APPLICATION NO.	FILING DATE	FIRST NAMED INVENTOR	ATTORNEY DOCKET NO.	CONFIRMATION NO.
10/051,965	01/16/2002	Shiann Liou	MP0116	1558

Office Action Summary	Application No.	Applicant(s)	
	10/051,965	LIOU, SHIANN	
	Examiner	Art Unit	
	Luan Thai	2827

DETAILED ACTION

FIG. 5

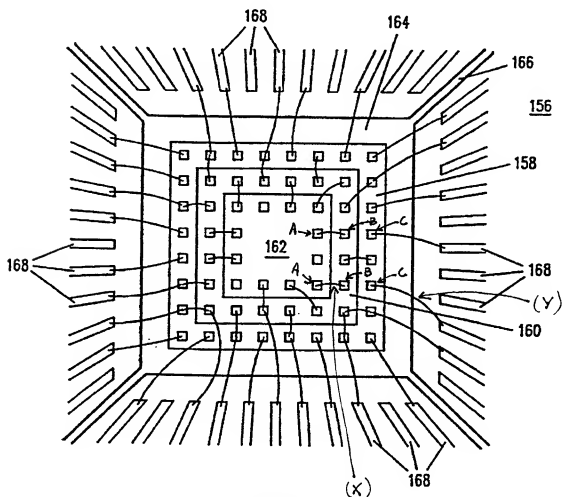
Regarding claims 1-2, 6-10, 14-16, 26, and 39-40 Takiar et al disclose (see specifically figures 5-6 attached) an integrated circuit comprising: a semiconductor die (158) including a plurality of pairs of electrical termination means (e.g., bond pads A/B) and electrical termination means (e.g., bond pads C) connected to the connecting means (e.g., lead fingers 168); each pair of electrical termination means (e.g., bond pads A/B) having a single corresponding means (e.g., bond wire X) connected thereto such that each electrical termination means (e.g., bond pads A/B) of the pair of electrical termination means has only one end of any means (e.g., one bond wire end) for conducting connected thereto, wherein the first and the second electrical termination means (e.g., bond pads A and B) are located in the internal portion of the semiconductor die (158), and wherein the single corresponding means (e.g., bond wire X) would inherently be one of power interconnect, ground interconnect, or signal interconnect. Takiar et al further disclose the second electrical termination means (e.g., the second bond pad B) being located along a periphery of the semiconductor die (158) (see figure 6).

FIG. 6

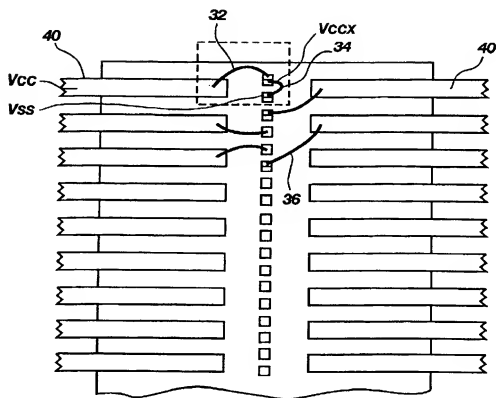
Although Takiar et al do not explicitly disclose the electrical termination means (e.g., bond pads C) being I/O electrical termination means (or I/O bond pad), it would have been obvious for at least one of lead finger (168), which is electrically connected to the electrical termination means (e.g., bond pads C) via bond wire (Y), to be an
